Access Compliance Report Public Rights-of-Way (Curb Ramps)

Main Street: SANTO_TOMAS_ST		Cross Street: SANTA_ANA_AVE		Location:	N
ADA ID: RPAT220128165320	Ramp Type:Type 1 - Perpendicular	Initial Pass/Fail: Fail	Overall Compliance: No	Severity Score:	16

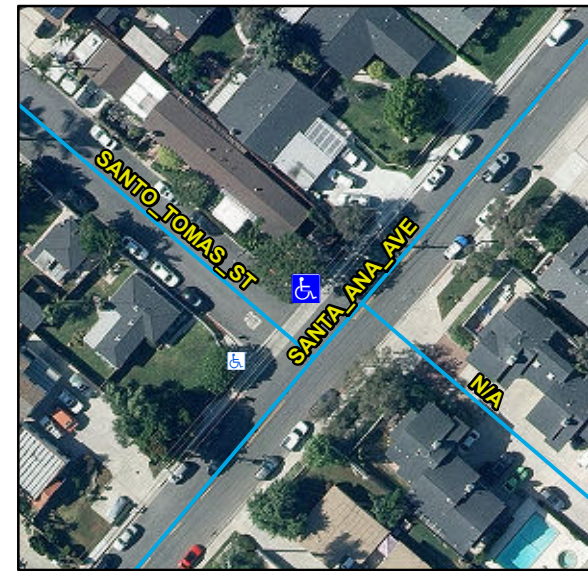
Compliance	Description	Data	Compliance	Description	Data
N/A	Ramp Length (in)	75	N/A	Flare Type LT	
Yes	Ramp Width (in)	64			N/A
Yes	Ramp Run Slope (%)	2.3	N/A	Flare Slope LT (%)	N/A
No	Ramp Cross Slope (%)	2.3	N/A	Flare Traversable LT	N/A
N/A	Landing Present	N/A	N/A	Flare Type RT	
N/A	Landing Length (in)	N/A			N/A
N/A	Landing Width (in)	N/A	N/A	Flare Slope RT (%)	N/A
N/A	Landing Run Slope (%)	N/A	N/A	Flare Traversable RT	N/A
N/A	Landing Cross Slope (%)	N/A	N/A	DWS Provided	N/A
N/A	Landing Movement Obstructed?	N/A	N/A	DWS Contrast	N/A
	Landing Movement Type	N/A	N/A	DWS Length (in)	N/A
N/A	Landing Shared	N/A	N/A	DWS Full Width	N/A
N/A	Clear Space	N/A	N/A	DWS Offset Left (in)	N/A
N/A	Clear Space To Crosswalk (in)	N/A	N/A	DWS Offset Right (in)	N/A
N/A	Marked Crosswalk 1	No	N/A	Marked Crosswalk 2	N/A
	Crossing 1 Direction	SW		Crossing 2 Direction	N/A
	Marked Crosswalk 1 Width (in)	N/A		Marked Crosswalk 2 Width (in)	N/A

N/A	Ramp Inside Crosswalk 1	N/A	Yes	Ramp Inside Crosswalk 2	N/A
	Crossing 1 Slope (%)	2.7		Crossing 2 Slope (%)	N/A
	Crossing 1 Cross Slope (%)	2.8		Crossing 2 Cross Slope (%)	N/A
N/A	Gutter Ponding	N/A	No	Curb Slope	5.8
Yes	Gutter Lip Height (in)	0		Road Run Slope (%)	N/A
N/A	Gutter Run Slope (%)	N/A		Road Cross Slope (%)	N/A
N/A	Gutter Cross Slope (%)	N/A			
No	Overall Surface Condition:	Poor	No	Perp Joint Present	No
	Cross Gutter Present?	Yes		Spandrel Present?	Yes
	Replace Cross Gutter?	No		Replace Spandrel?	No

Remove & Replace Entire Ramp.
